HOLDOVER

Revised

OAK HOLLOW ESTATES SUBDIVISION

APPLICATION NUMBER Holdover DATE September 16, 2004

OAK HOLLOW ESTATES SUBDIVISION

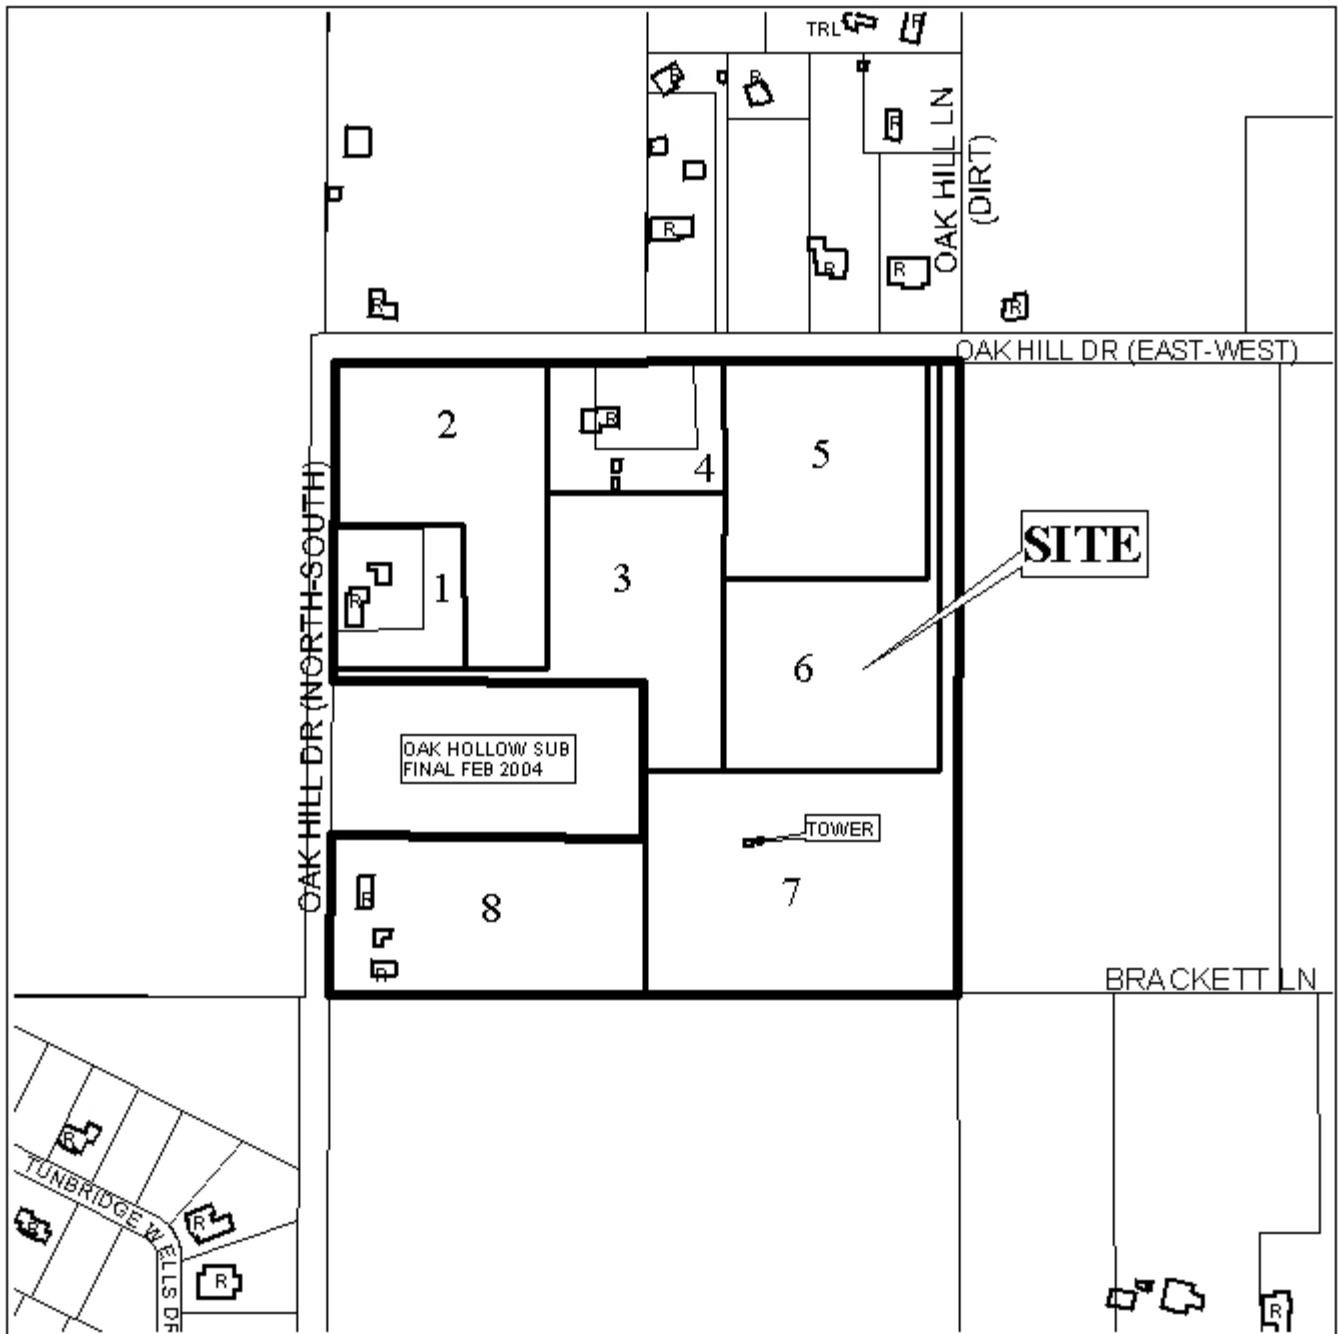
Engineering Comments: Must comply with the Mobile County Flood Damage Prevention Ordinance.

This site is located in the County, thus a note should be placed on the final plat stating that any lots which are developed commercially and adjoin residentially developed property must provide a buffer, in compliance with Section V.A.7. of the Subdivision Regulations.

The 25-foot minimum building setback lines are not shown but would be required on the final plat.

As proposed, the site illustrates there will be three flag shaped lots which would require a waiver of Section V.D.3. (width to depth ratio) of the Subdivision Regulations. Flag shaped lots are not compatible with the surrounding area and therefore, Section V.D.3. should not be waived. However, a possible option is that the site be subdivided into seven lots, with one flag shaped lot fronting Oak Hill Drive (North-South) and another flag shaped lot fronting Oak Hill Drive (East-West). Moreover, a note should be placed on the final plat stating that there can be no future resubdivision of the flag shaped lots until the additional frontage (50-foot right-of-way) is provided to an open and maintained public right-of-way.

With modifications and a waiver of Section V.D.3. (for a total of two flag shaped lots), the plat will meet the minimum requirements of the Subdivision Regulations and is recommended for Tentative Approval as a seven lot subdivision subject to the following conditions: 1) the placement of a note on the final plat stating that there shall be no resubdivision of flag shaped lots until a minimum of 50-feet of frontage is provided to an open and maintained public right-of-way; 2) the placement of a note on the final plat stating that any lots which are developed commercially and adjoin residentially developed property must provide a buffer, in compliance with Section V.A.7. of the Subdivision Regulations; and 3) the placement of the 25-foot minimum setback lines on the final plat; and 4) that the site be limited to two flag shaped lots, one facing Oak Hill Drive (North-South) and one facing Oak Hill Drive (East-West).
